# Technical Service Bulletin

## 68 Noises from the MMI screen

68 22 37 2061722/3 June 6, 2022. Supersedes Technical Service Bulletin Group 68 number 21-31 dated January 14, 2021, for reasons listed below.

*Figure 2. Apply two pieces of felt tape to the dash panel in the area shown.*

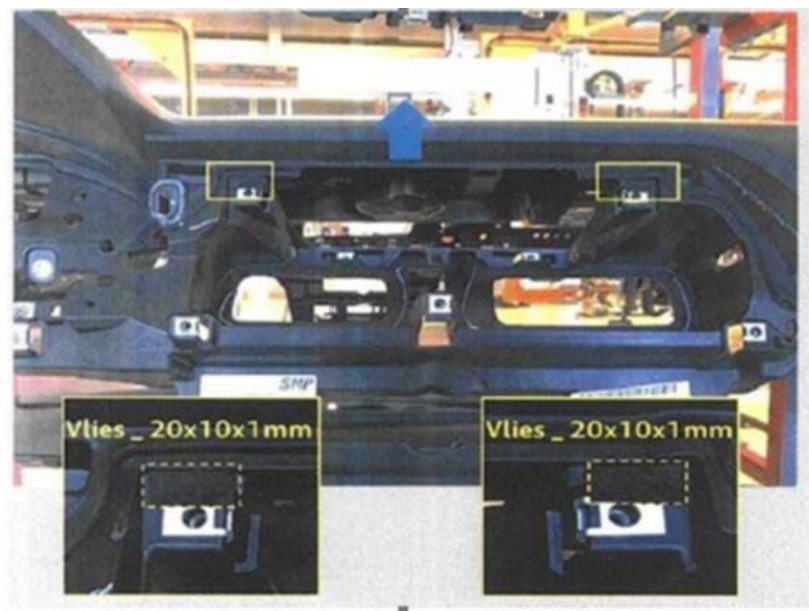
Attach two pieces of felt tape to the MMI screen mounting surfaces in the dash panel (Figure 2).

- Felt strips with part number 533867910A (dimensions: 20x10x1 mm).
